Service Bulletin No. SB-AG-44

OIL VENT TUBE MODIFICATION

MODEL S2R-G10, S/N G10-101 THRU G10-168

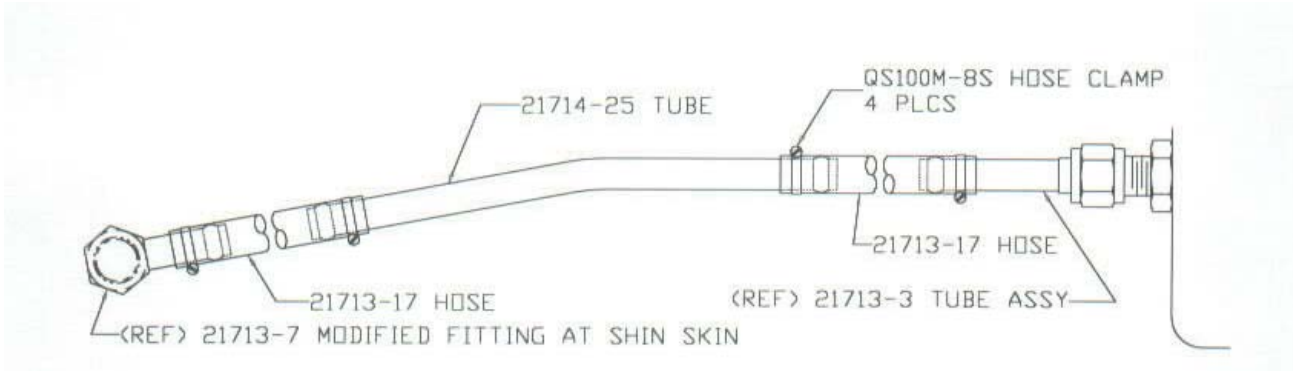
The airplanes produced to date have used a 74 inch piece of MIL-H-6000 rubber hose for this vent installation. It runs from the right lower aft face of the gear box along the right lower engine mount longeron to an outlet on the shin cowl. The way that it is routed, it passes too close to the hot parts of the engine. The exhaust passes out of the nacelle in this area. This results in rapid deterioration of the first 3.5 ft. of the hose starting at the engine gear box.

1. Remove the rubber hose (MIL-H-6000) used for the oil vent line. It starts at the lower, right aft face of the engine gear box. It is routed along the right lower longeron of the engine mount truss.
2. Replace it with the new line made from ½-inch aluminum tubing. The aluminum line has a segment of high temperature, flexible hose on each end. Two extra hose clamps are part of the kit. See sketch on page 2.
